Solicitation No. 26-FM-0010

Amendment No. 3

ADDENDUM NO. 2

Project: Oklahoma Department of Transportation – Multipurpose Facility
Location: Stillwater, Oklahoma
Issued Date: 23 January 2026

SITE PLAN EAST

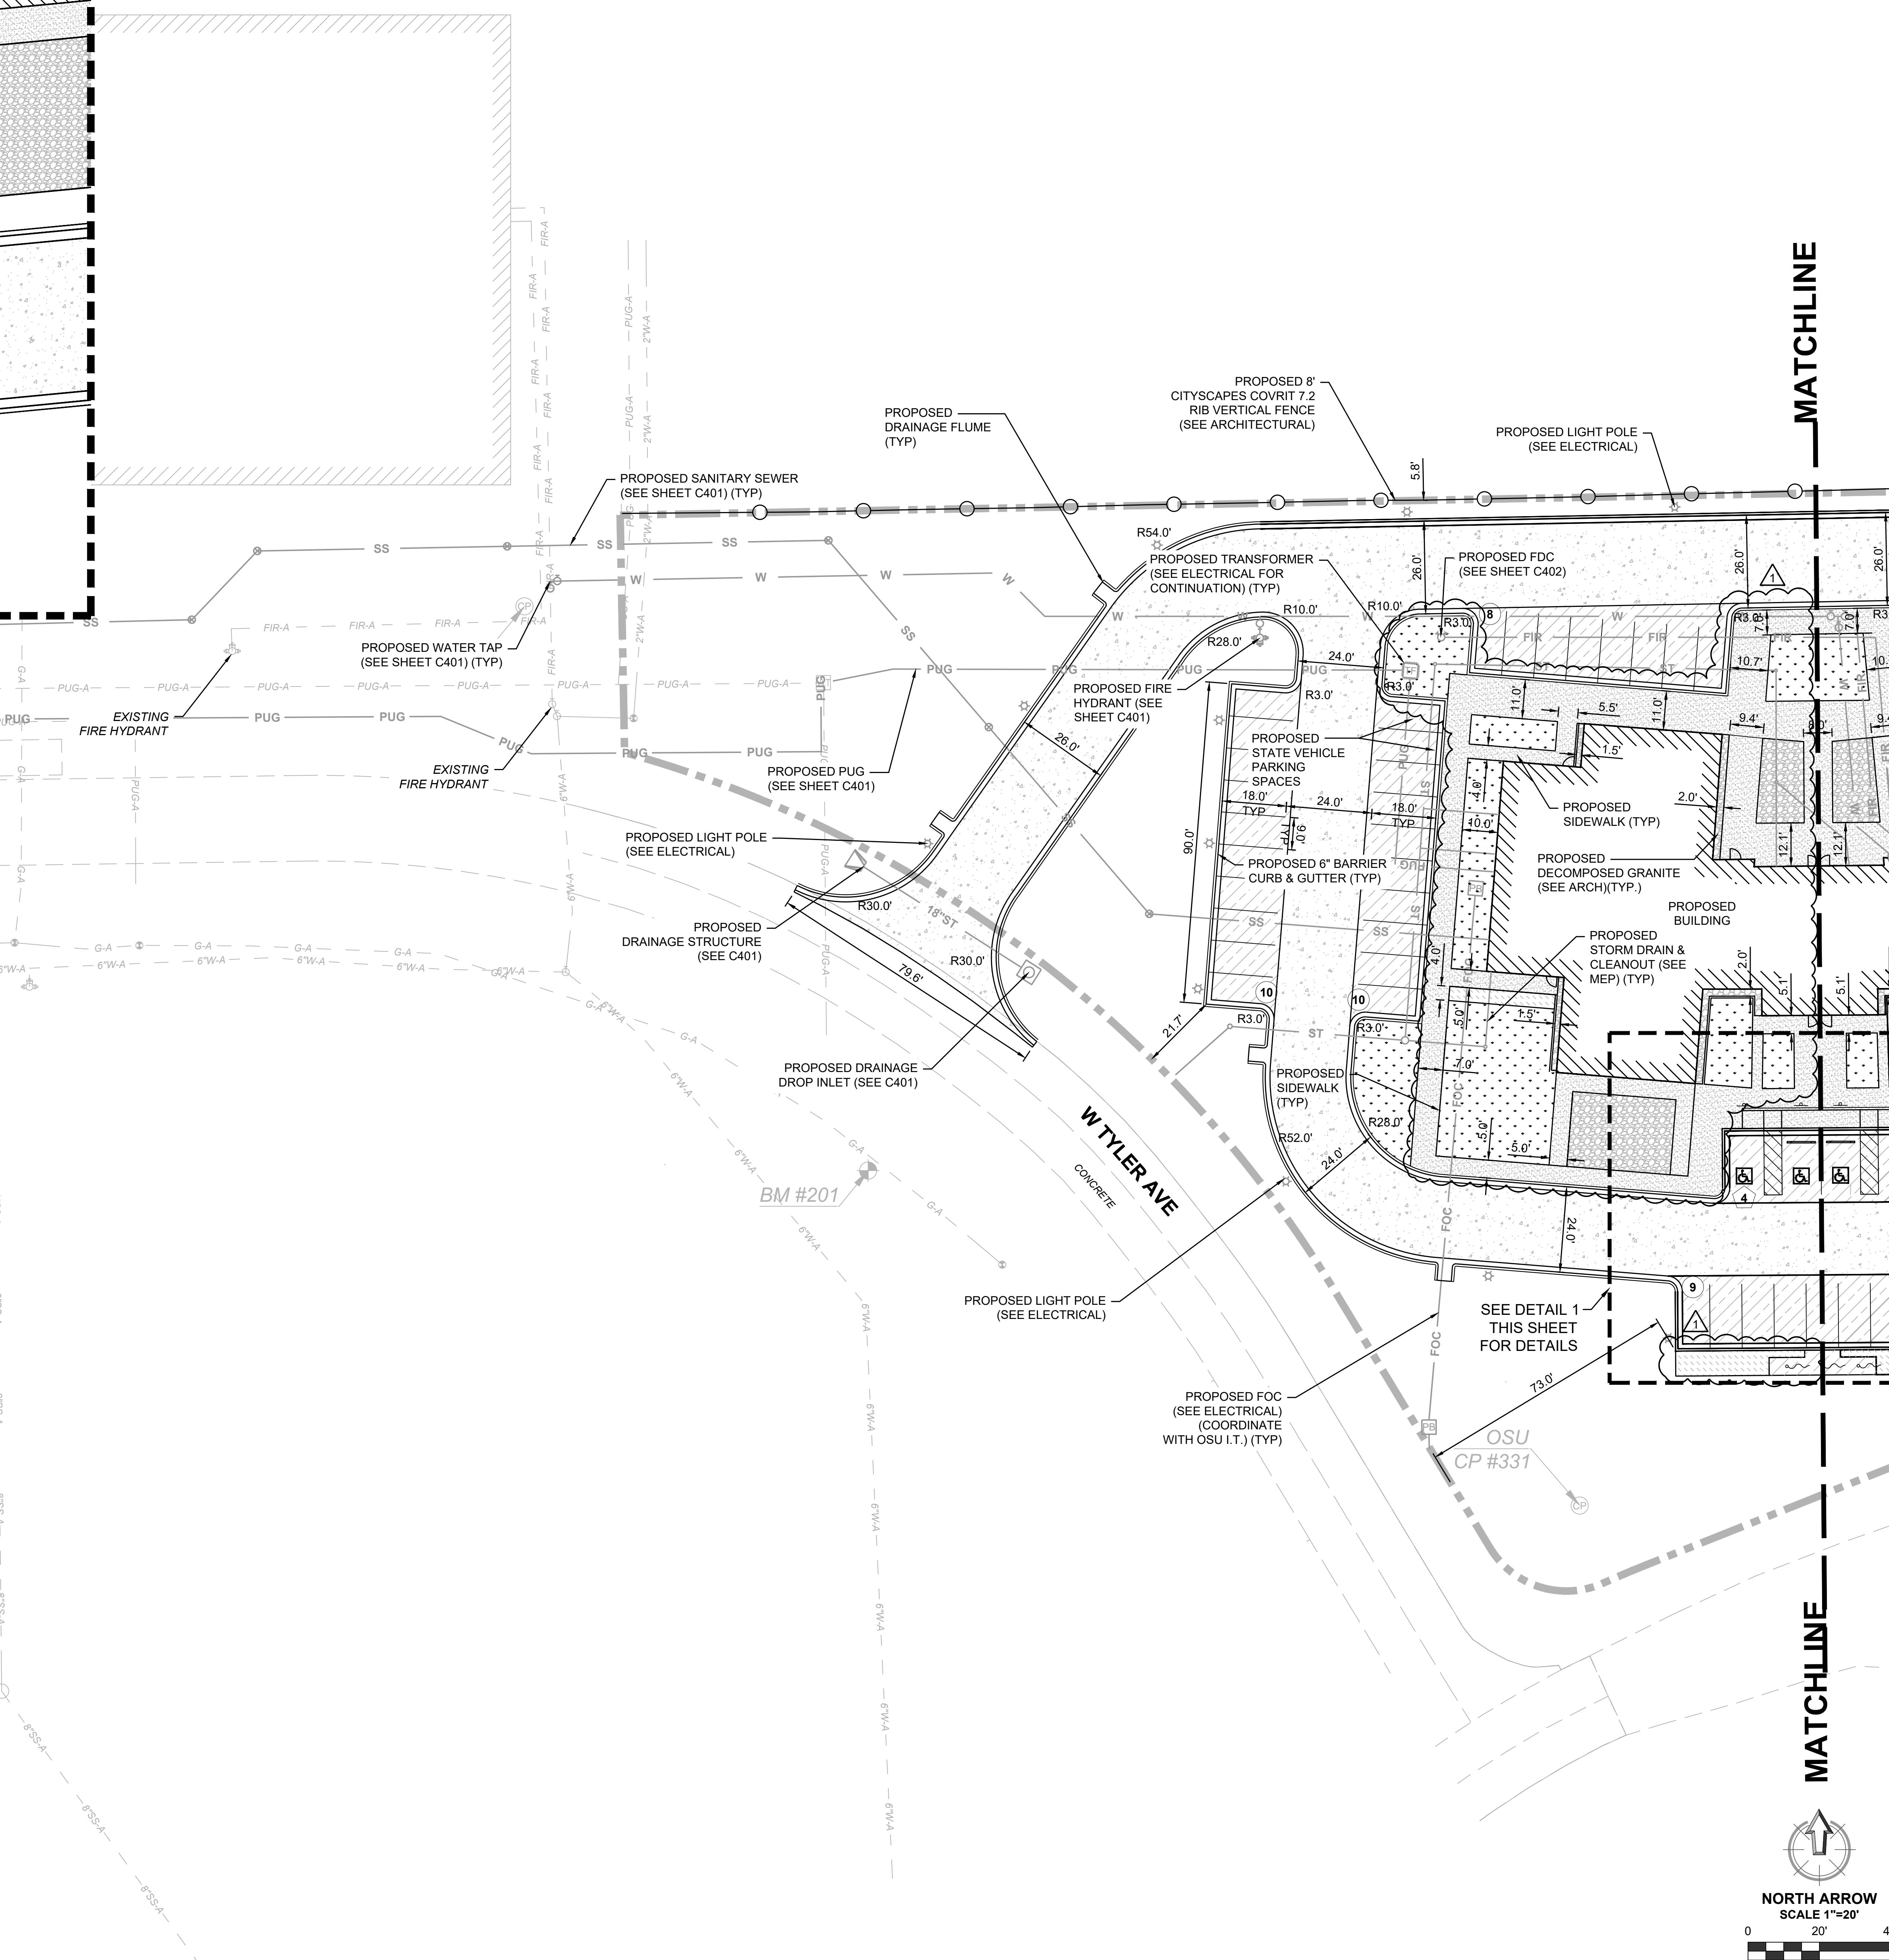
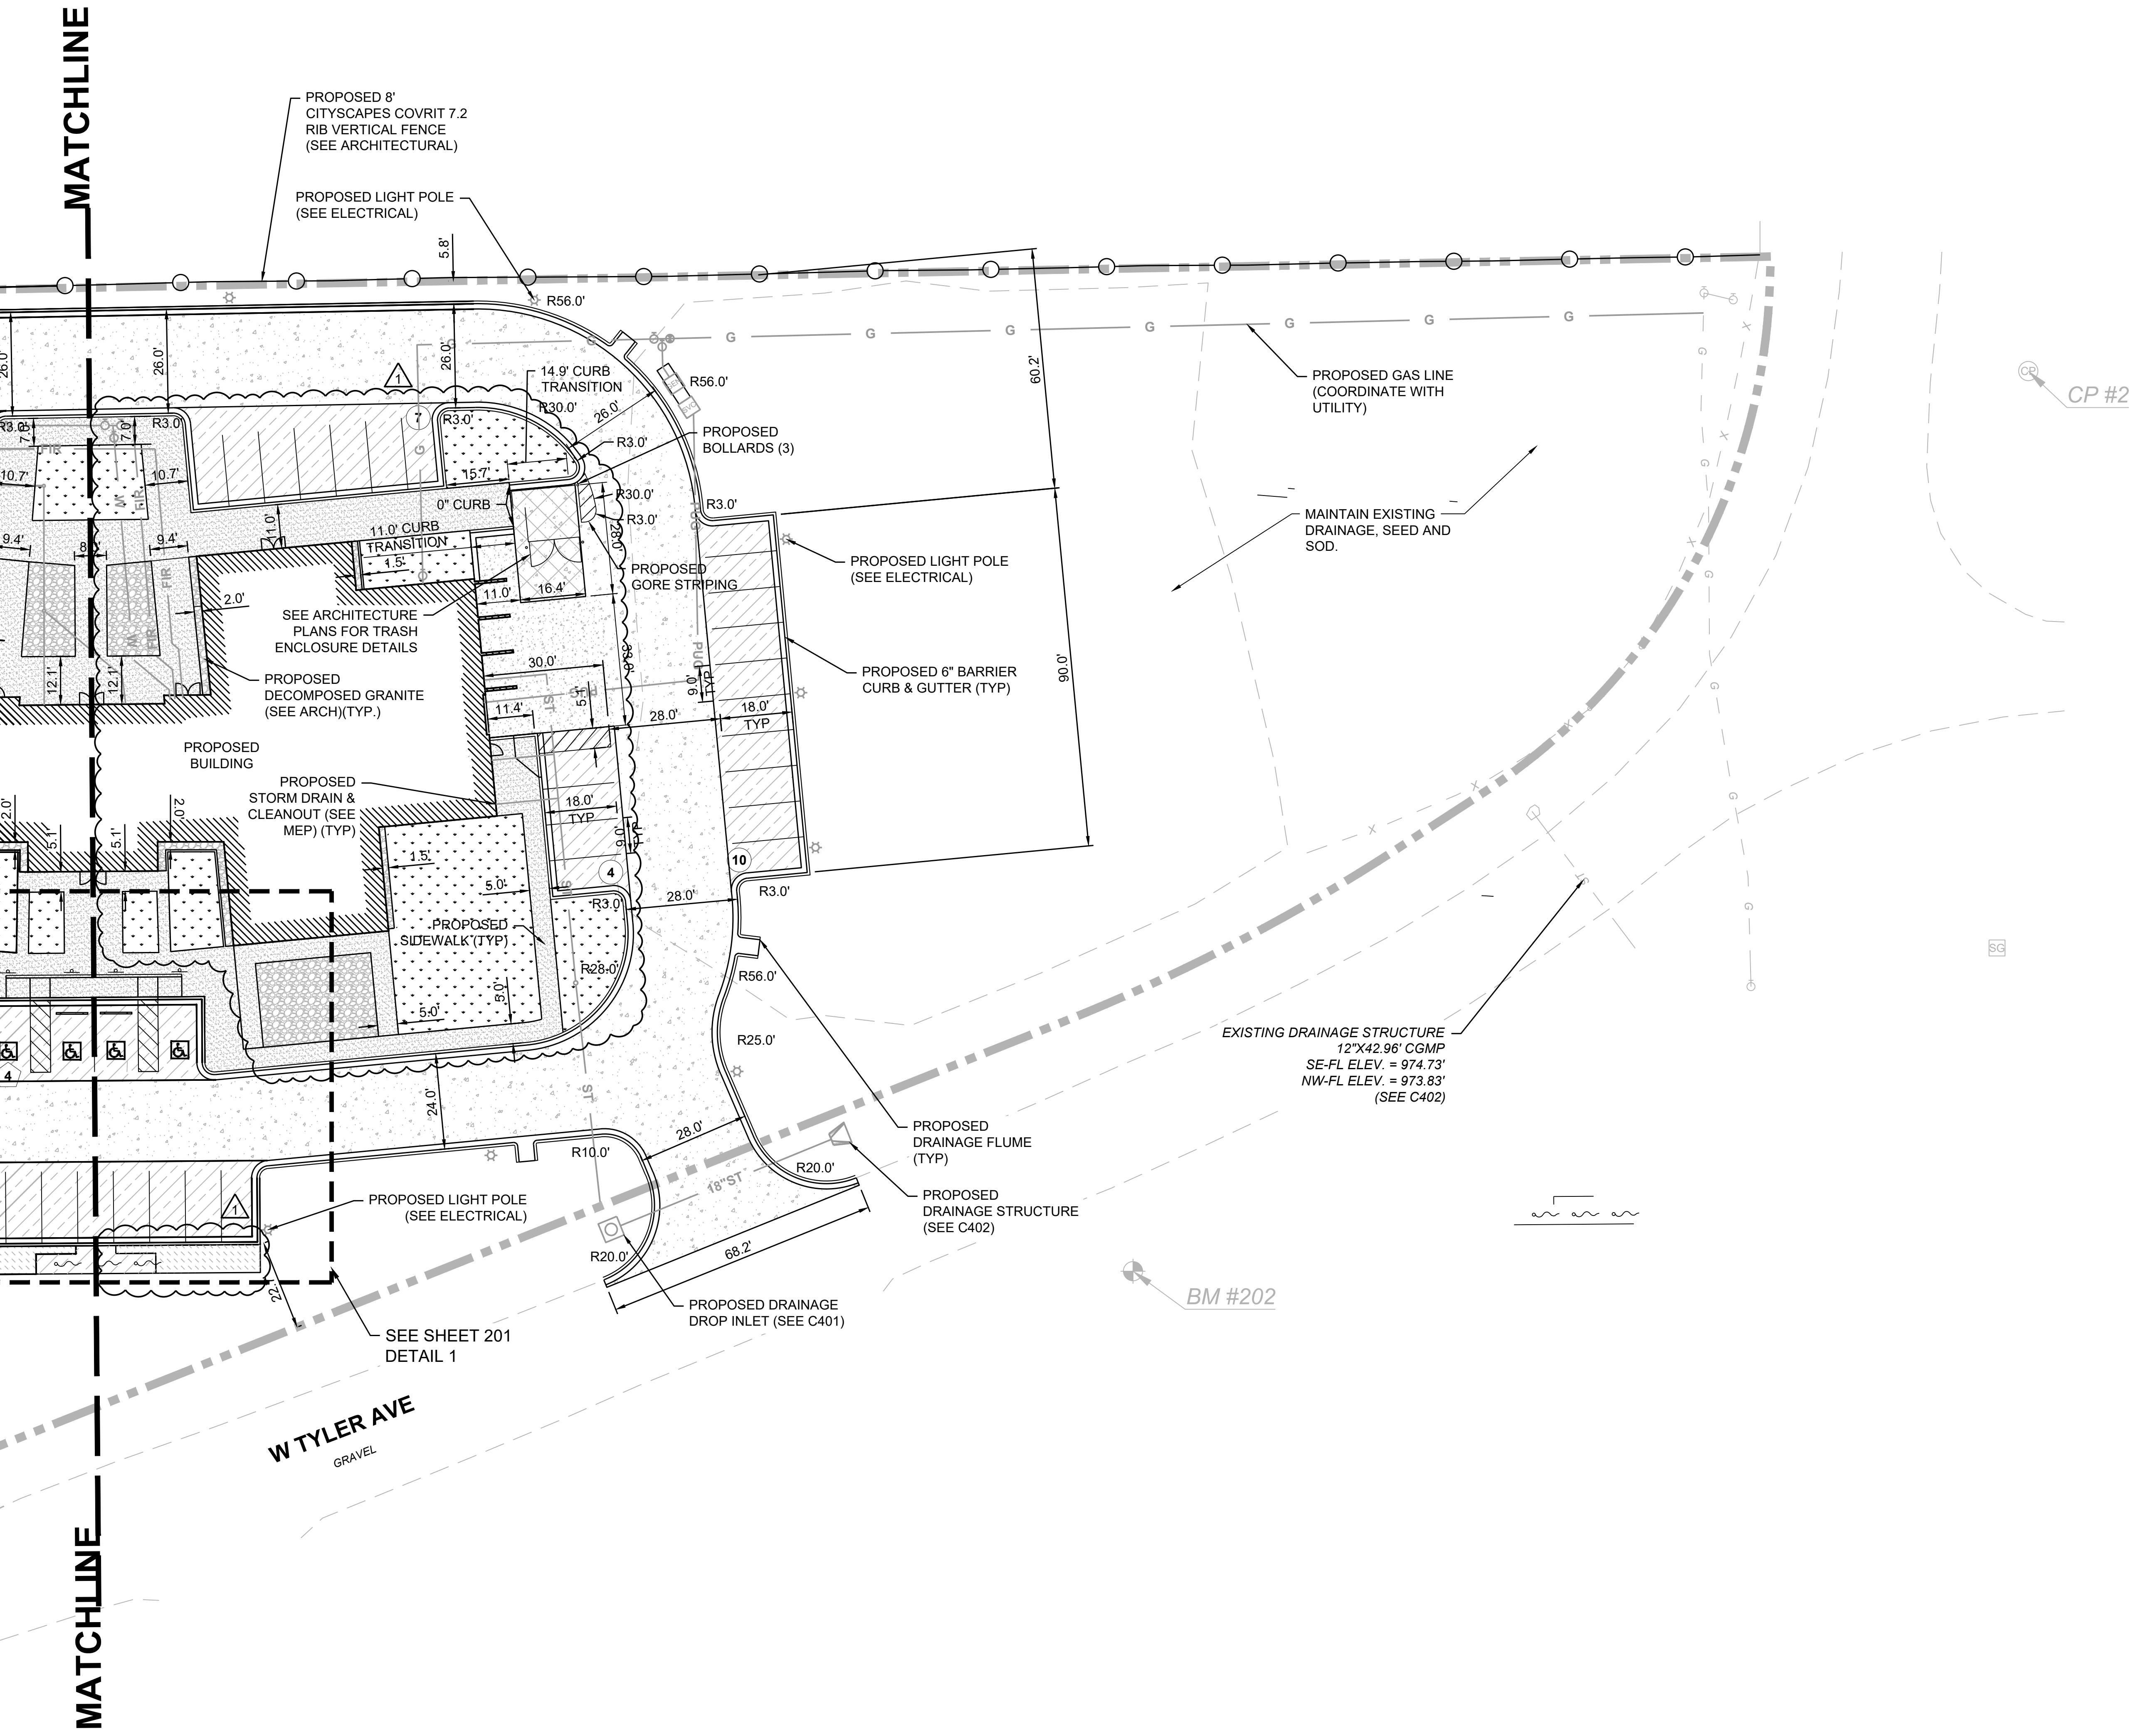
1. Removed retaining wall callouts (no retaining wall on project.)
2. Updated pavement hatches around building and legend.
3. Added flagpole area

ODOT OSU MULTIPURPOSE FACILITY	
ELECTRICAL ONE-LINE DIAGRAM & SCHEDULES	
SHEET	SHEET
E002	
REVISION HISTORY	
SUBMITTAL: CONSTRUCTION DOCUMENTS	DATE
DATE: 09/12/2025	NO. DESCRIPTION 1 ADDENDUM 2
PROJECT NO.: 221001	DATE
DESIGNED BY: DN	01/22/2026
DRAWN BY: DN	
REVIEWED BY: AP	
SCALE: AS INDICATED

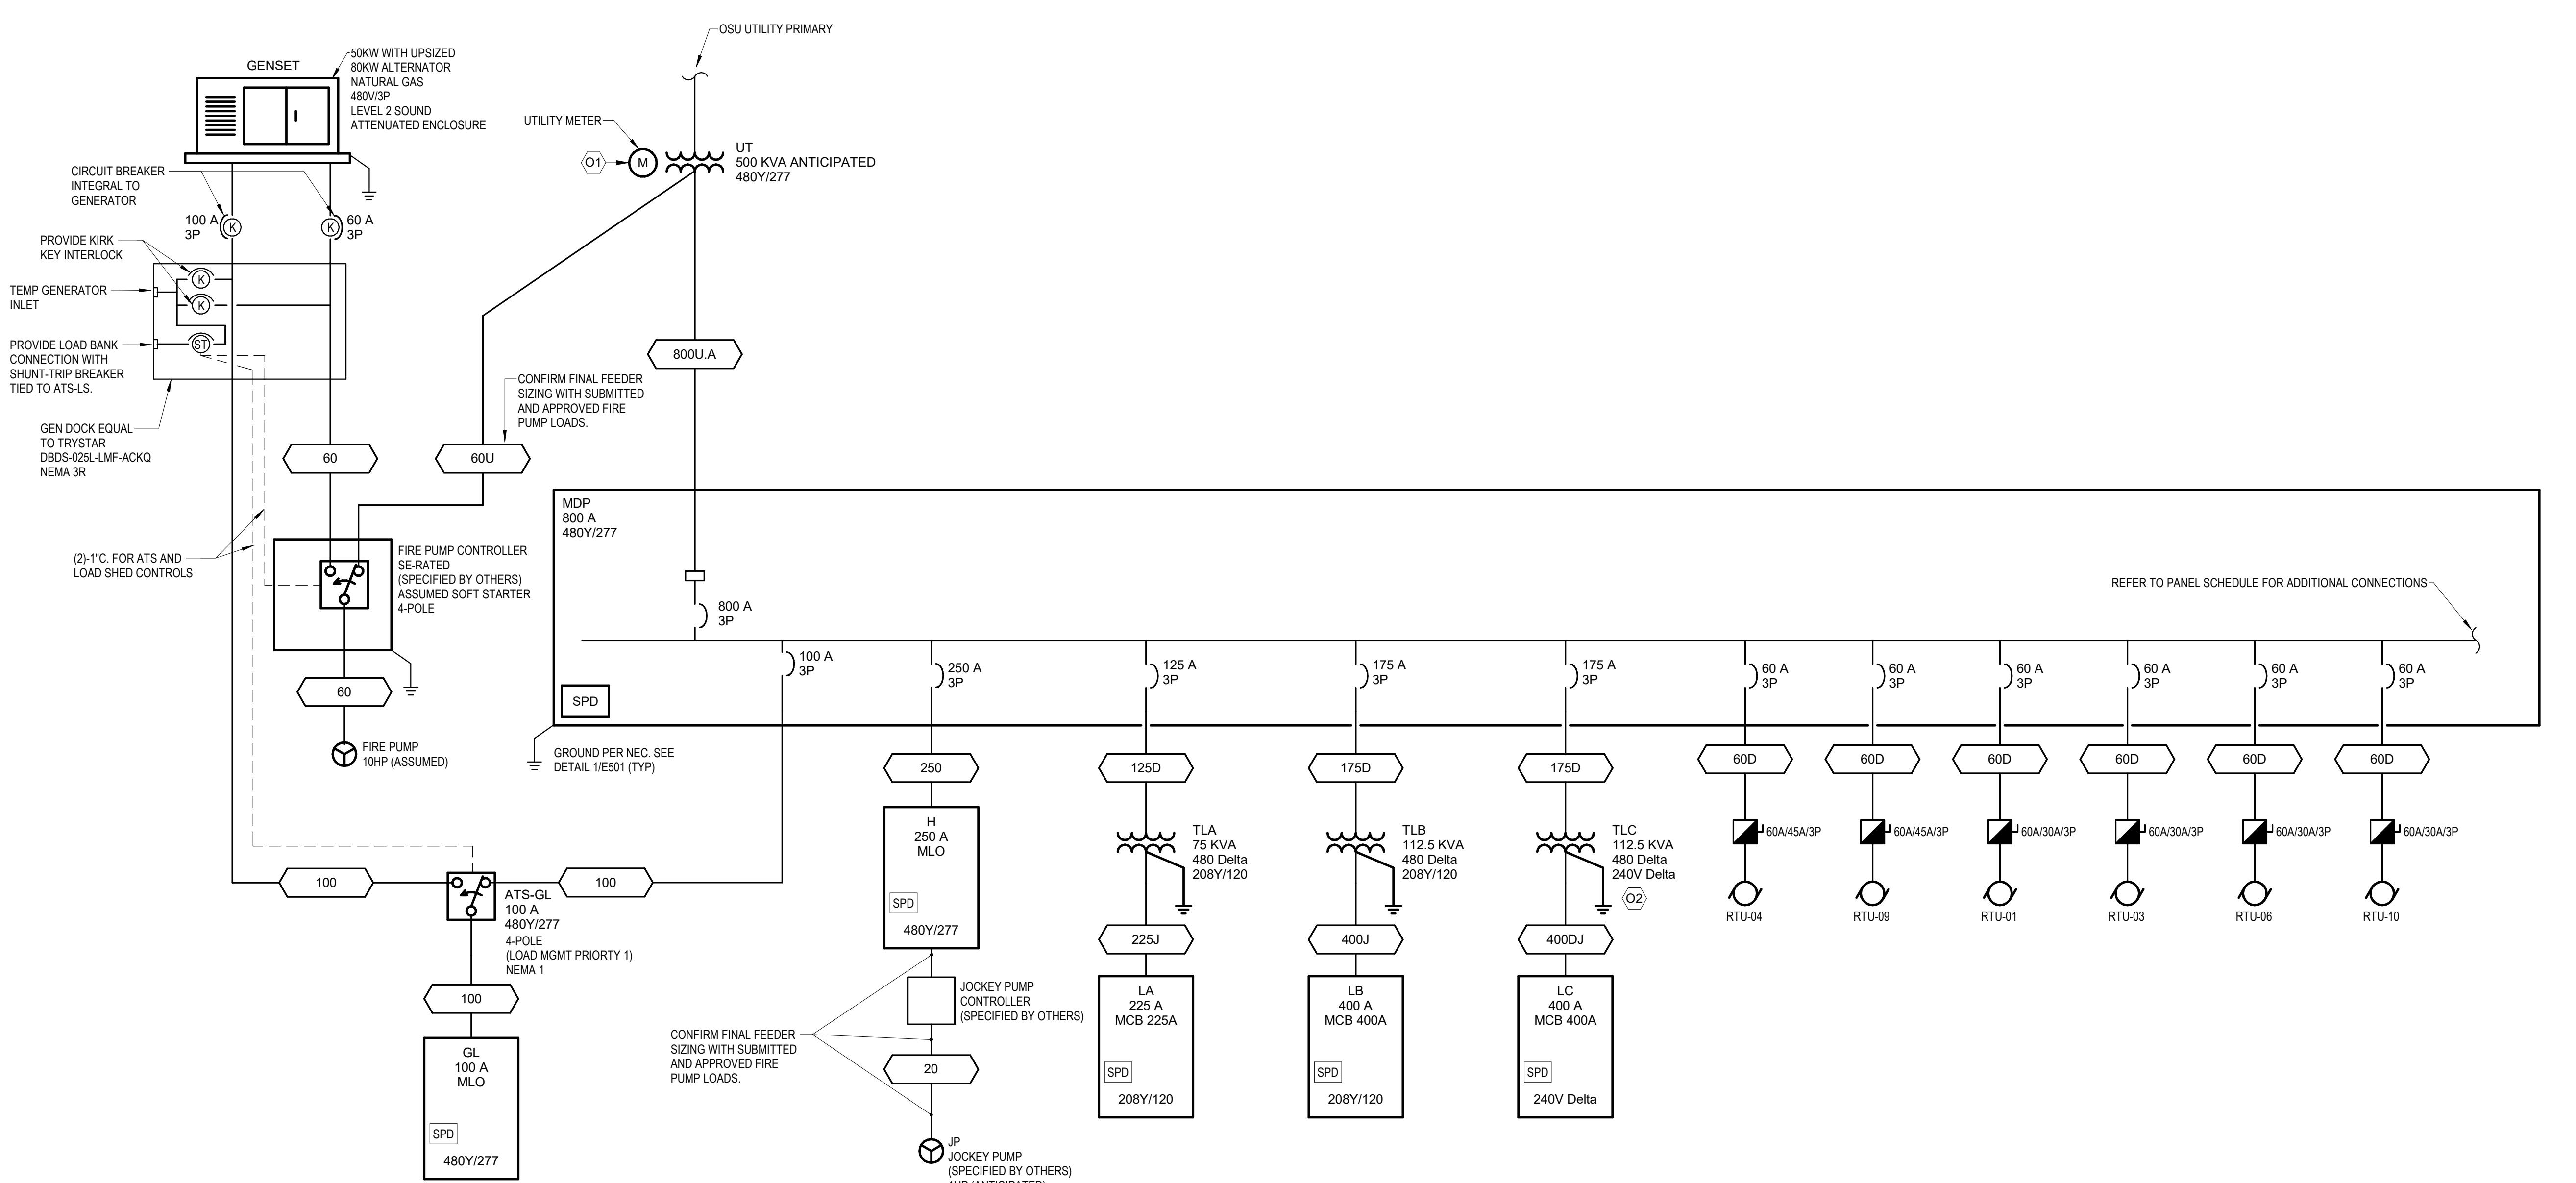
1. Revised conduit size per OSU utility comments.

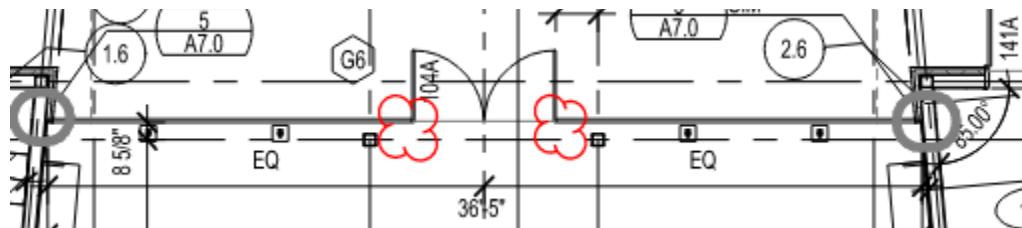
Q 49: For the north wall, the drawings appear to be missing some structure. See below snip from sheet A2.0. We will need to add structure at the clouded locations. Can you confirm that this is acceptable?

A 49: Confirmed, additional fins can be provided at the edges of the glass. It is also acceptable to provide a freestanding portal at the door. Refer updated drawings in upcoming addendum.

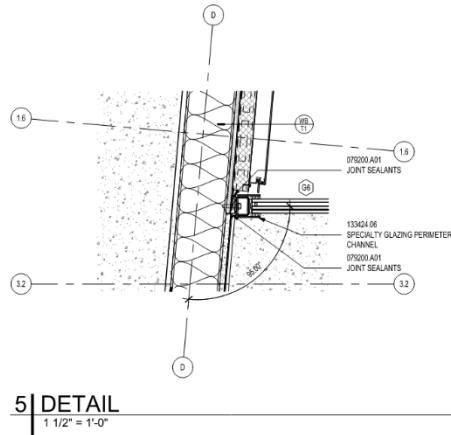
Q 50: Can you confirm that no additional steel is needed at the jambs of the north wall? Is the wall material shown structurally sufficient to support the glazing system channels? Ref. detail 5/A7.0 (below).

A 50: See upcoming addendum.
